X.±5.0	X.±*	.X±2.0	.X±*	.XX±1.0	.XX±	SCALE 1:1	TITLE Conn. RM1,25 Housing + Cable4x(1061)-30mm
X.±5.0	X.±*								
.X±2.0	.X±*								
.XX±1.0	.XX±								
DRAWN Walter		REV A-1	DRAWING NO SM C03 3212 04H+Cable 4xAWG28-30mm						
DATE 07.11.22		FILE NO							
APPROVAL Vanda		DATE

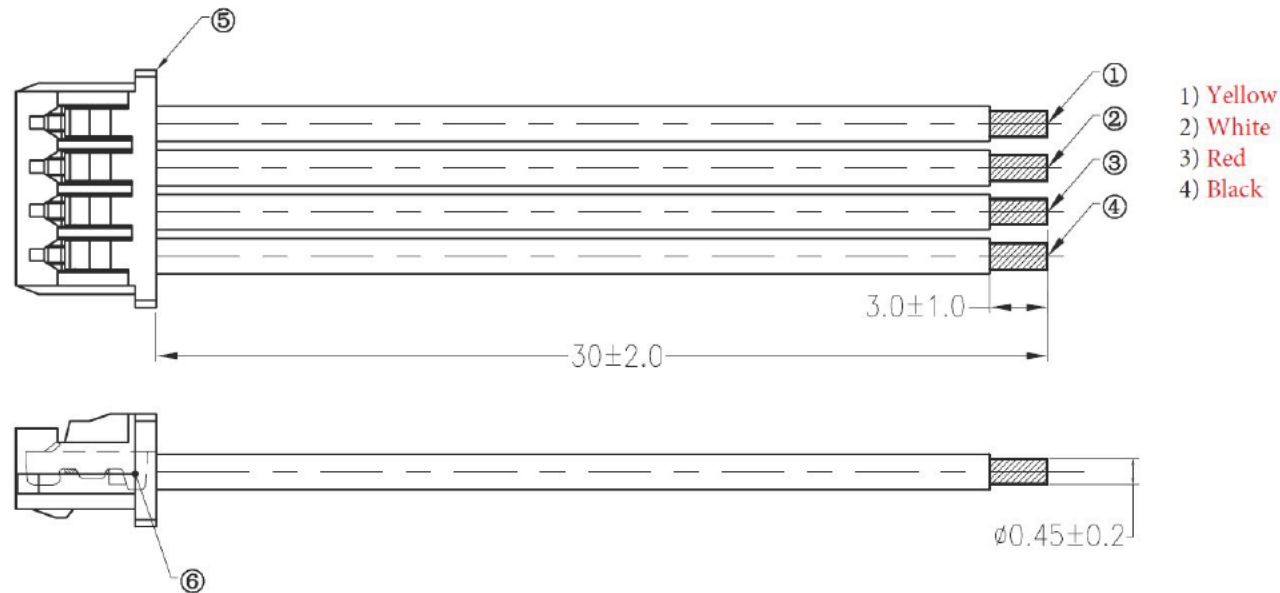
Change Cable UL-1569 28AWG to UL-1061 28AWG (OD=0.9mm)
